STAFF RECOMMENDATION
4105 Aberdeen Road
April 20, 2016

Application: New construction—addition and outbuilding; Setback determination

Description of Project: Construction of a rear addition and carport. A setback determination from three feet (3') to one foot, one inch (1'1") is requested for the right side of the addition, as the house is currently one foot and one inch (1'1") from the property line already.

1 SITE PLAN
SCALE: 1" = 20'

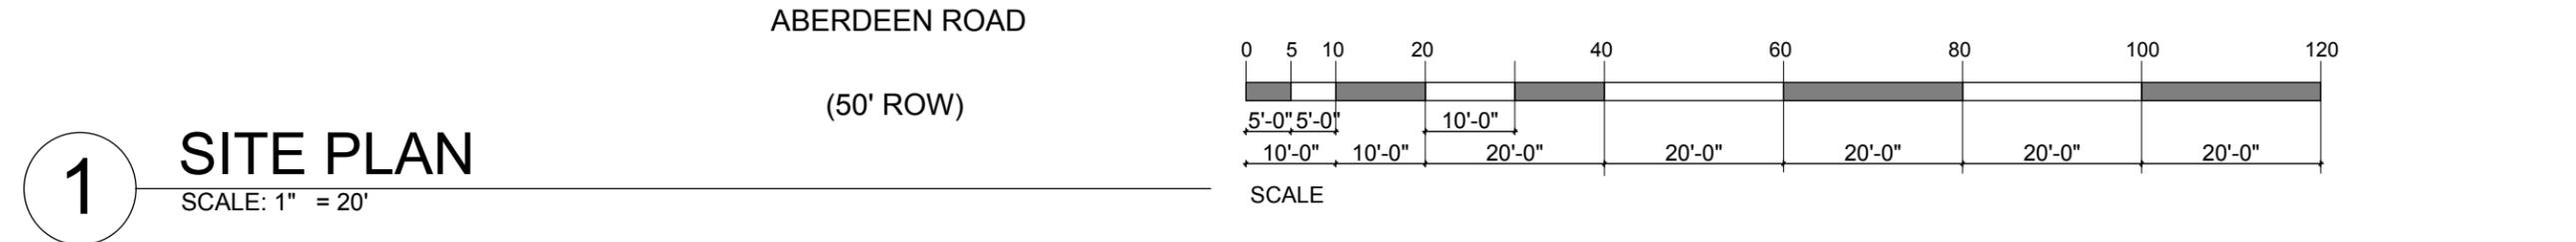
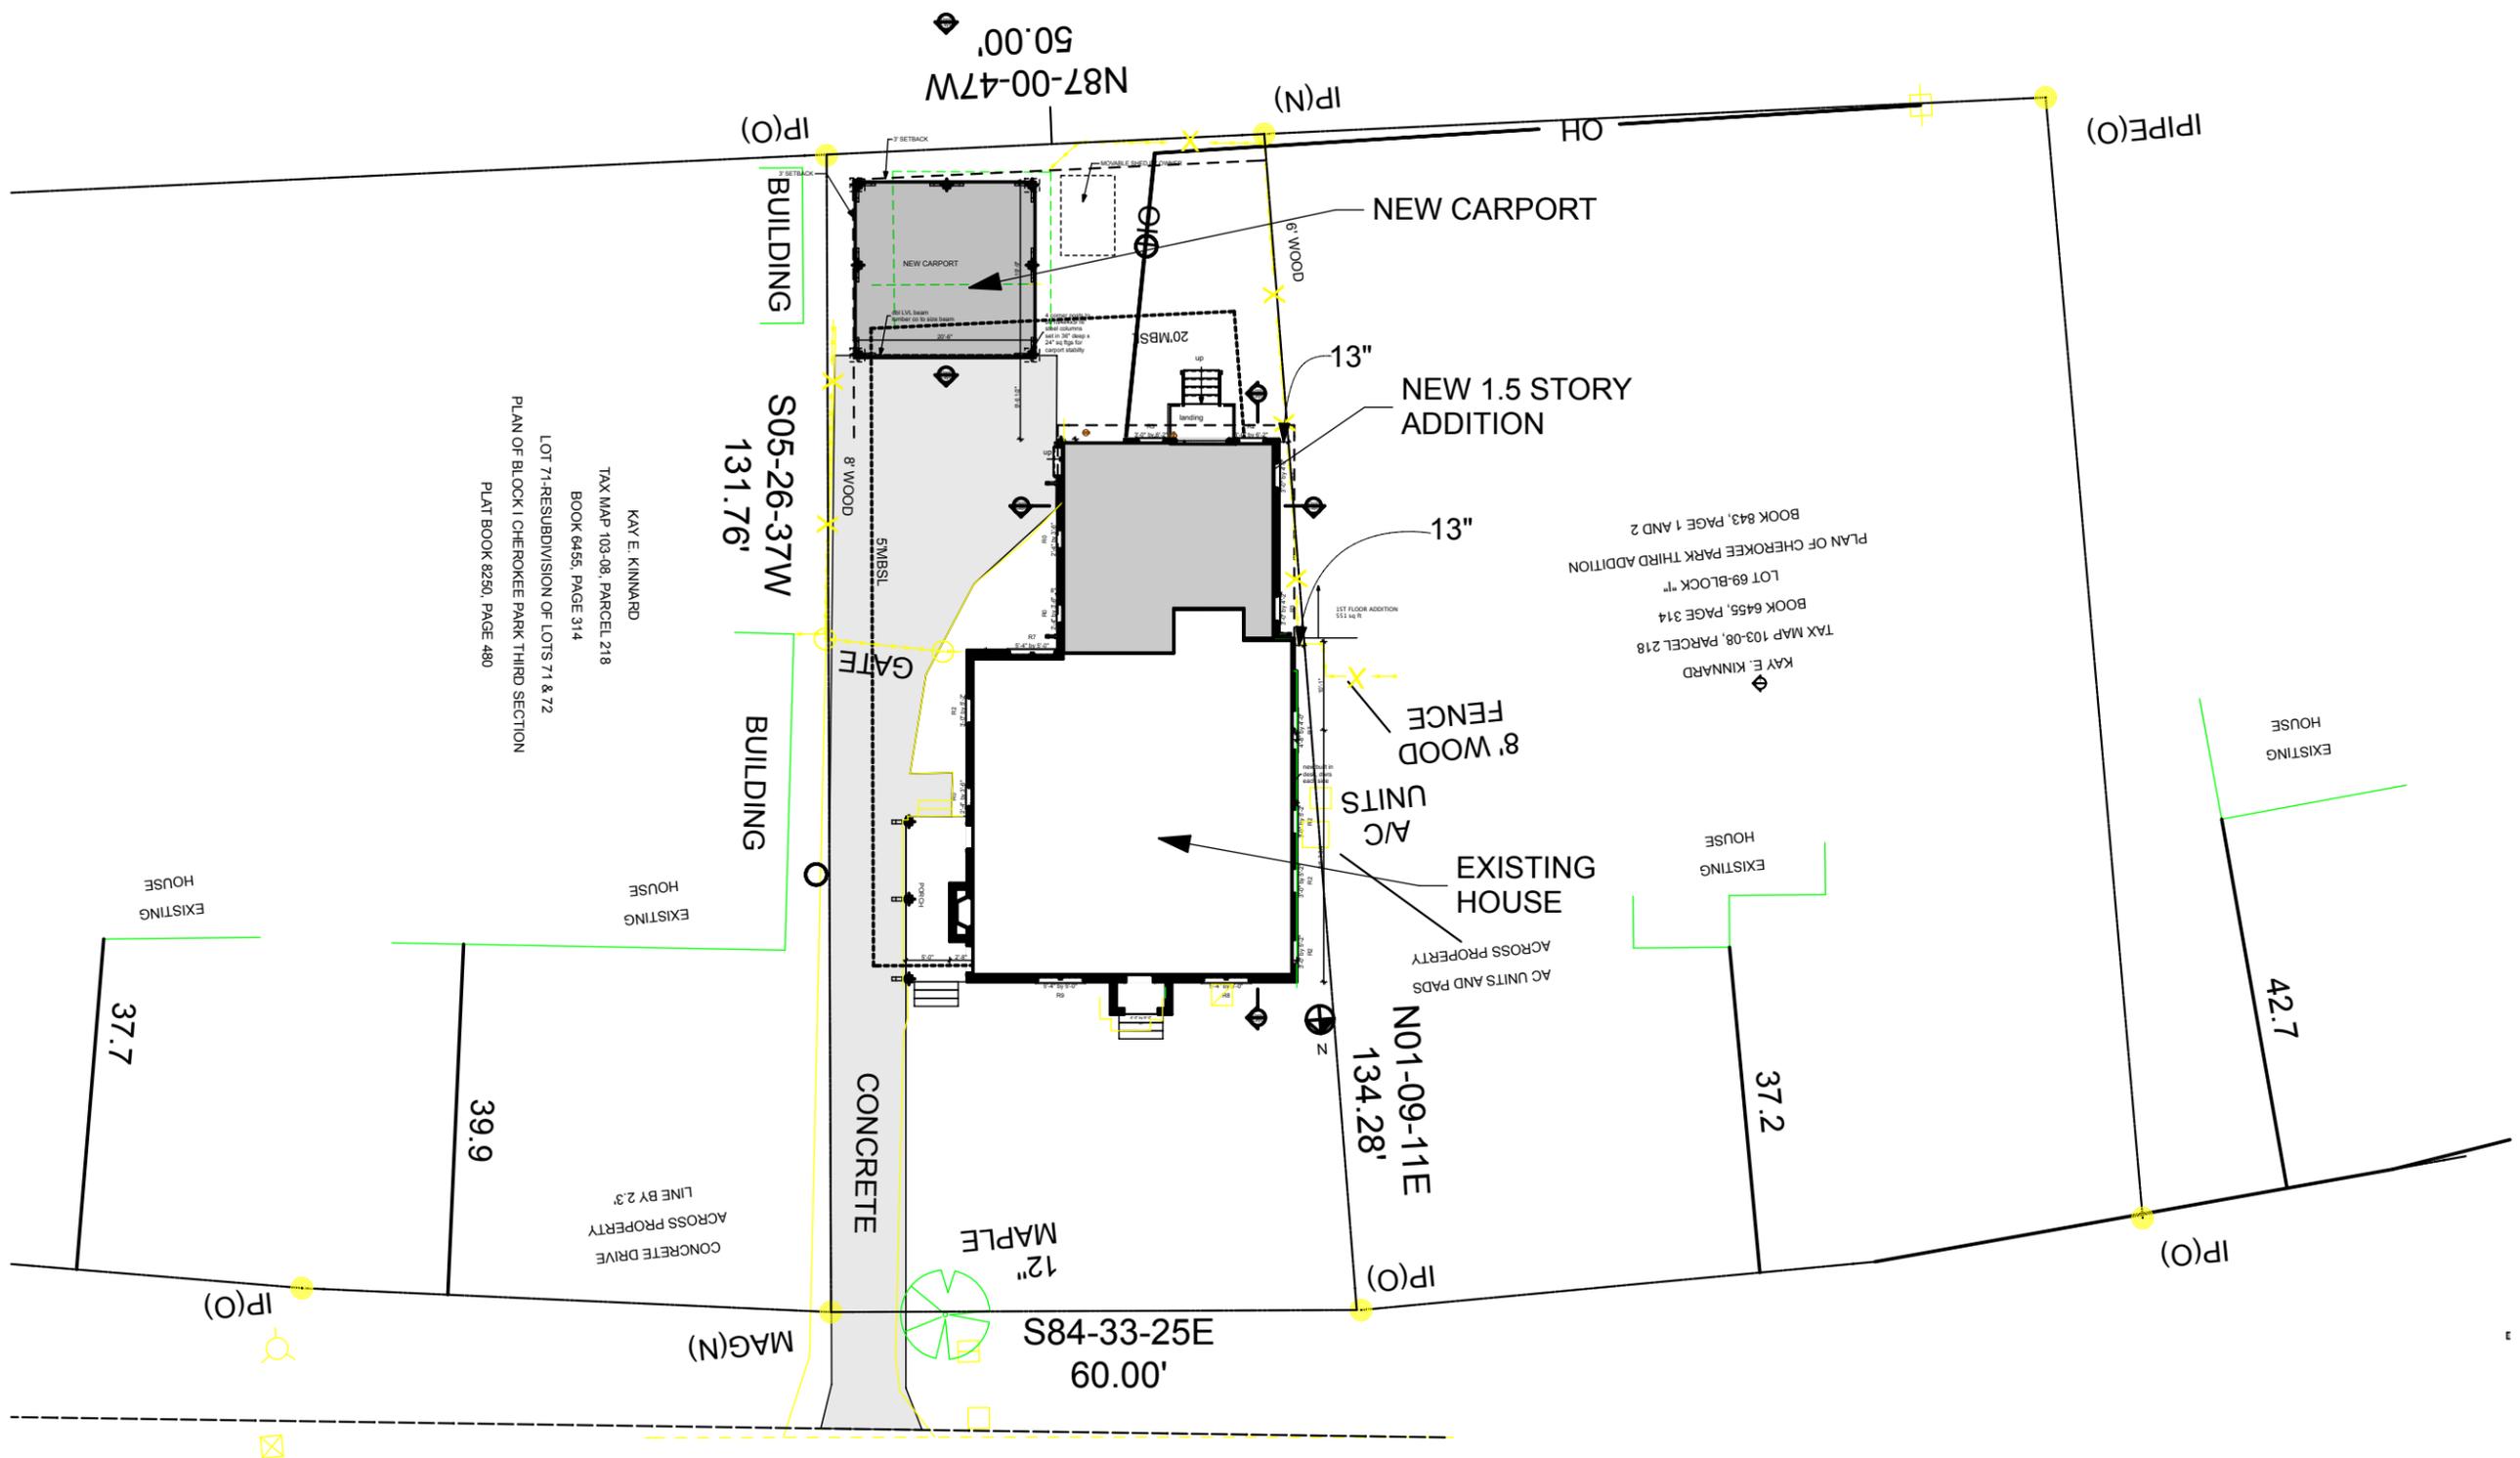
Setback & Rhythm of Spacing: The addition is not as wide as the house, but the right side of the house is only thirteen inches (13”) from the property line, because the lot narrows towards the back. Therefore a setback determination is required from three feet (3’) to one foot, one inch (1’1”). Staff finds the requested setback is appropriate, as the historic house is inside the setback area already.

1. Staff approve the final details, dimensions and materials of windows and doors prior to purchase and installation; and,
2. Staff approve the roof color and masonry color, dimensions and texture.

ELEVATIONS

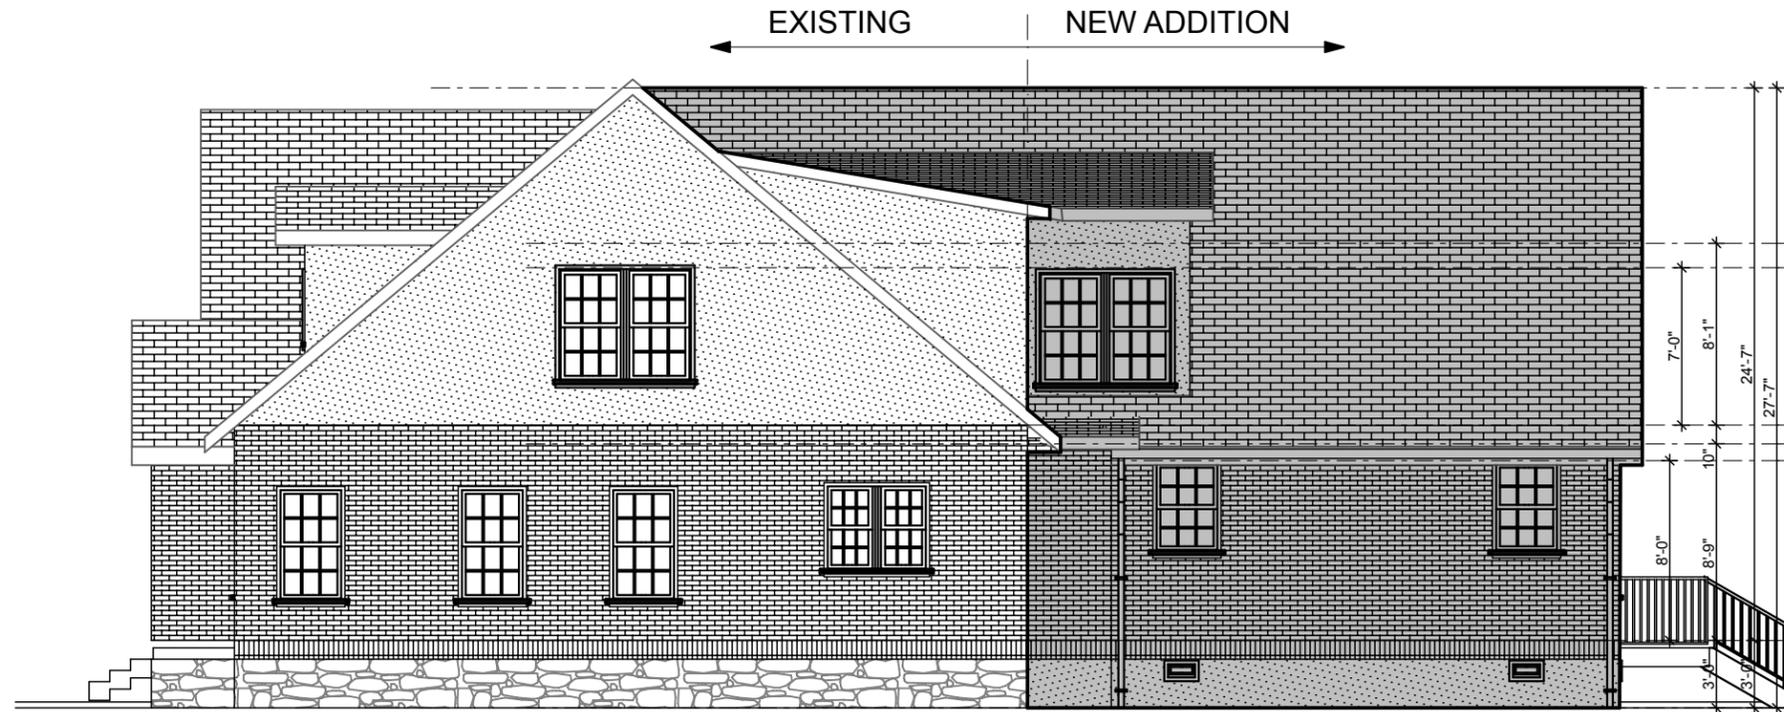
Roof form: The addition has a gabled roof with 14/12 pitch and a shed-roofed dormer on each side with 3/12 pitch. These roof forms are seen on neighboring buildings and are compatible with the historic context. The project meets section II.B.1.e.

Proportion and Rhythm of Openings: The windows on the proposed addition are generally twice as tall as they are wide, meeting the historic proportions of openings. There are no large expanses of wall space without a window or door opening. Staff finds the project's proportion and rhythm of openings to meet Section II.B.1.g.

CARPORIT

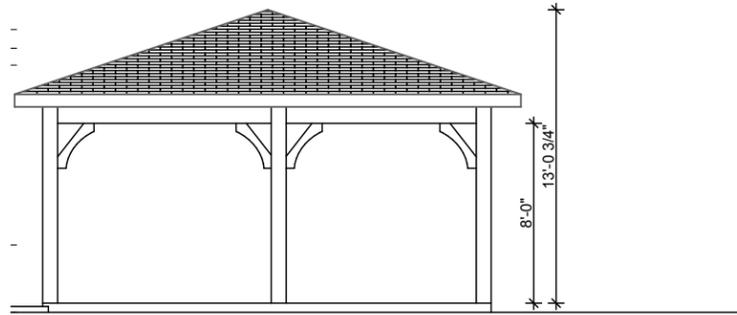
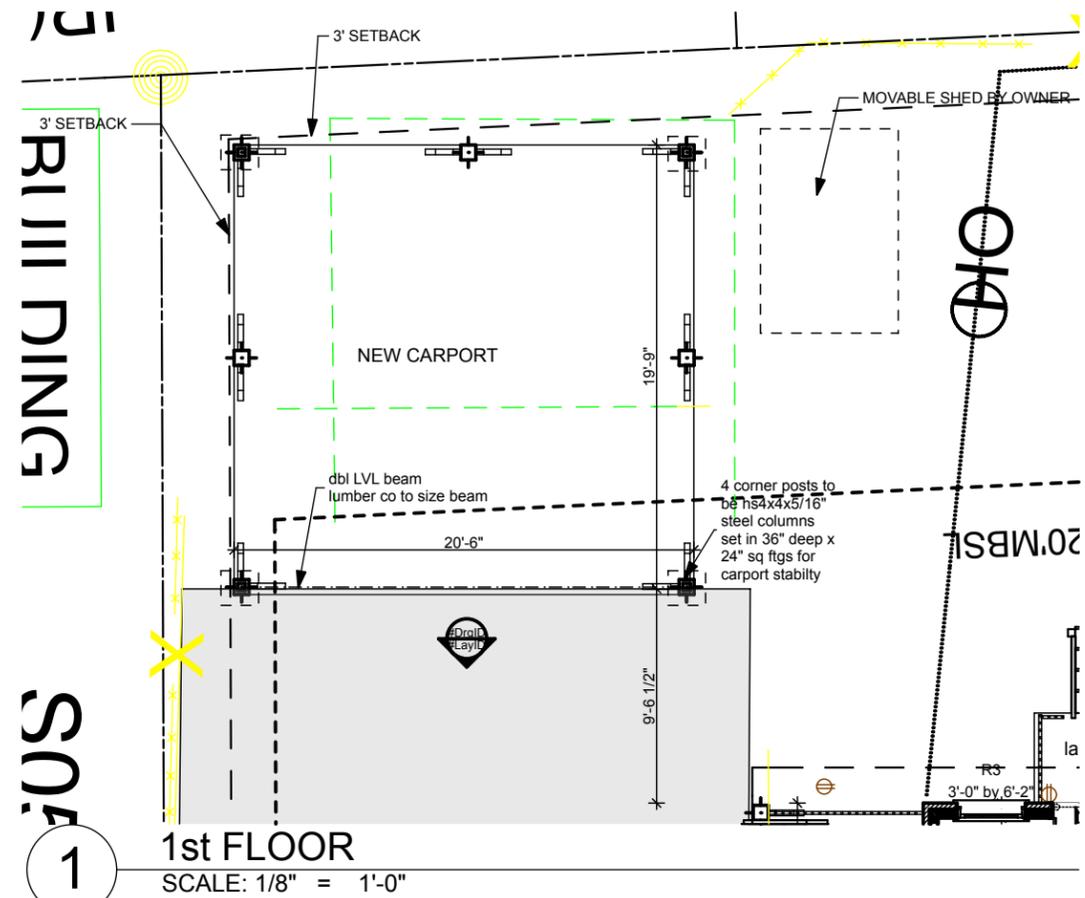
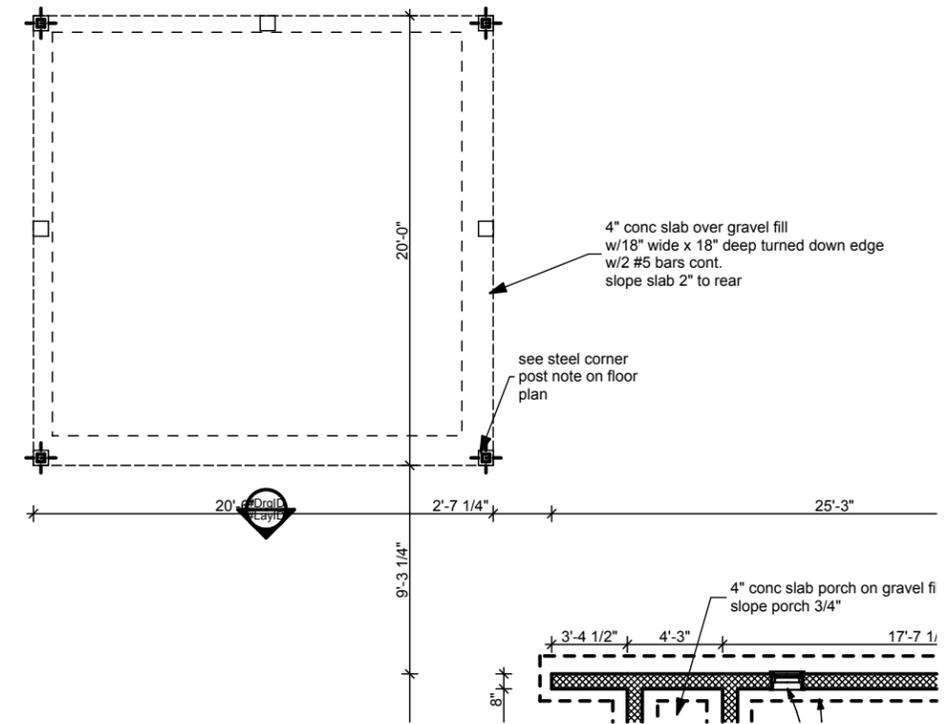
Outbuildings: A new carport will be built in place of the existing one. The proposed outbuilding measures twenty feet, six inches (20'6") by nineteen feet, nine inches (19'9") for a footprint of four hundred and five square feet (405 sq. ft.). It will have metal columns, wooden beams and an asphalt shingle roof. See attachment A, Outbuildings Worksheet, for details. The outbuilding meets section II.B.1.h of the design guidelines.
